ALERT SERVICE BULLETIN
REVISION NOTICE

SUBJECT: REVISION "A" TO ALERT SERVICE BULLETIN 412-08-128: MAIN ROTOR YOKES P/N 412-010-101-123/-127/-129/-133, REDUCTION IN AIRWORTHINESS LIFE FROM 5000 TO 4500 HOURS AND REIDENTIFICATION OF.

NO. 412-08-128

MODEL AFFECTED: 412 & 412EP

Figure 1

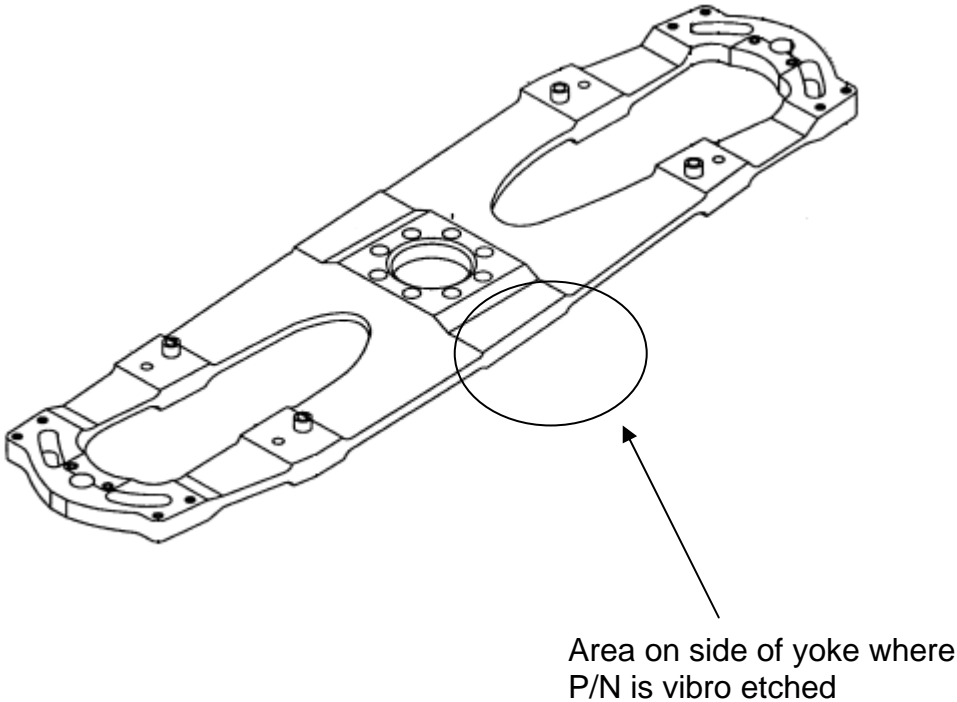
3. Locate marked P/N on side of yoke (Figure 1).
4. Using a vibrating stylus etch two lines through the dash number of the existing part number 412-010-101-~~423/~~ ~~427/~~ ~~429/~~ ~~433~~ yoke, and re-identify with -137FM. Characters to be 1/4" + or - 1/8 "high and located on center line within 1/8".

5. Treat etched surface with chemical film (C-100). Apply primer (C-204) and paint (C-245) per color code 36440.
6. On the Yoke component Historical Service Record, mark two lines through the dash number of the existing part number 412-010-101-~~423/~~ ~~427/~~ ~~429/~~ ~~433~~ and re-identify as 412-010-101-137FM adjacent to the original markings. Retain existing serial number.
